JEFFERSON PARISH

ADDENDUM # 1

Bid Number: 50-00139637

Description of Bid: One Time Purchase of Portable Restroom and Shower Combo Trailers for The Jefferson Parish Emergency Management Department

PICTURE FOR QUESTION #2)

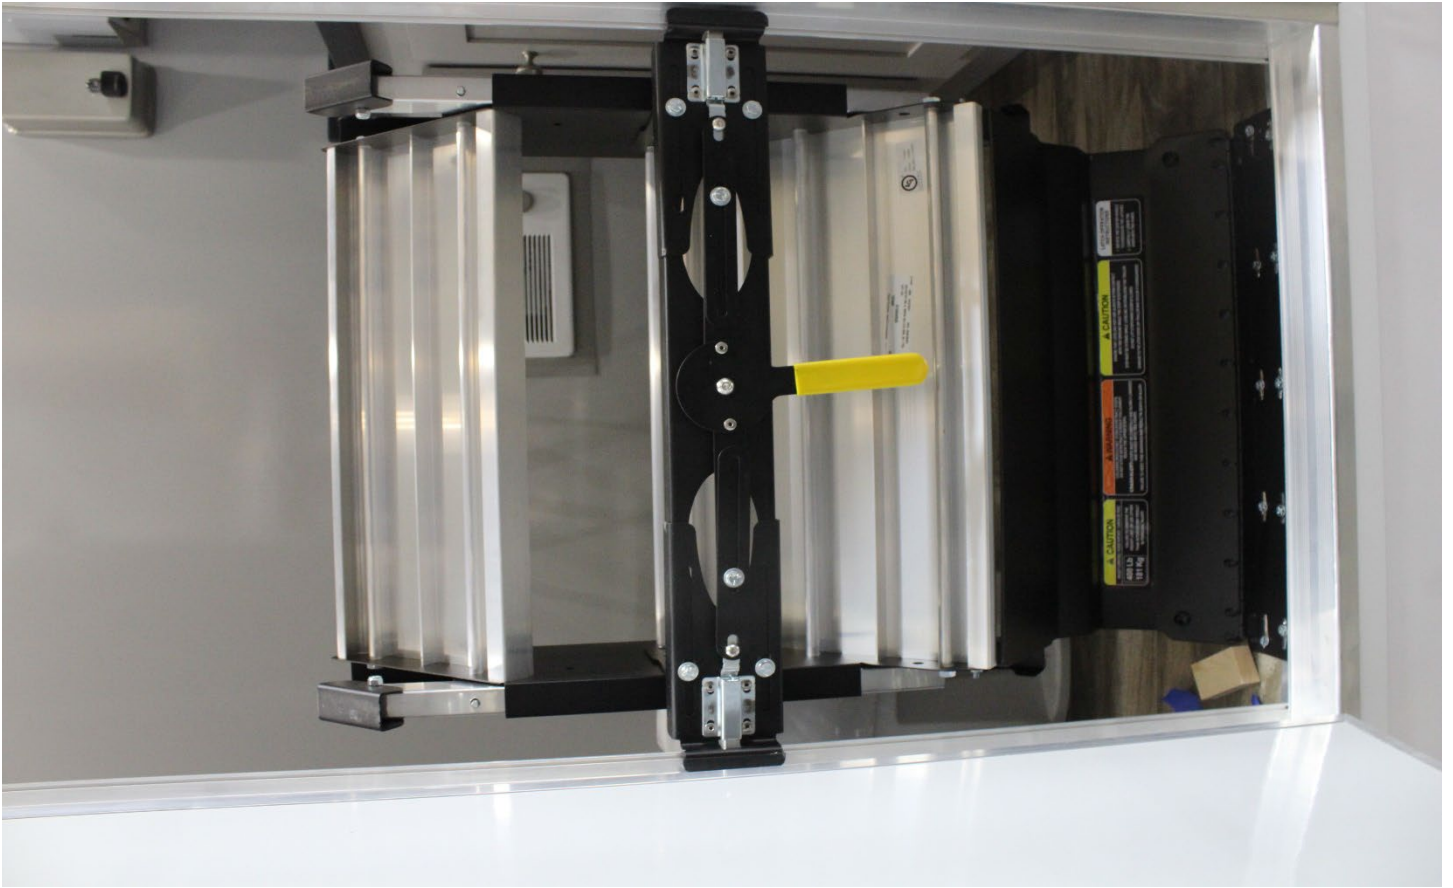
- 2) On the hydraulic lowering trailer, the stairs are not retractable. Single Step welded to frame (SEE ATTACHED PHOTO)

ANSWER: Single step is approved as long as trail is equipped with ada ramp.
